IMSA TECHNICAL MEMO IPC #21-02

Re: LMP3 Gearbox Vent and Lubricant Fill Quantity

Vent exit locations:

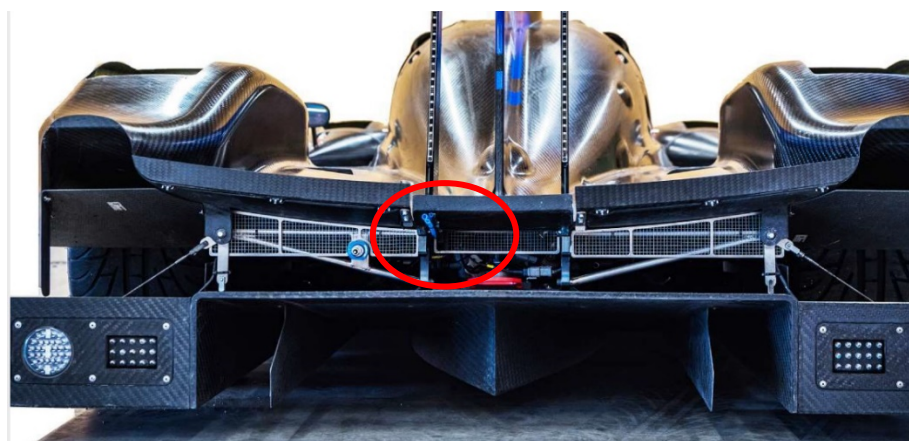
The required gearbox vent line routing is shown in the following photograph. The exit of the line should be flush with the homologated screen, not protruding more than 5.0 mm from the screen.
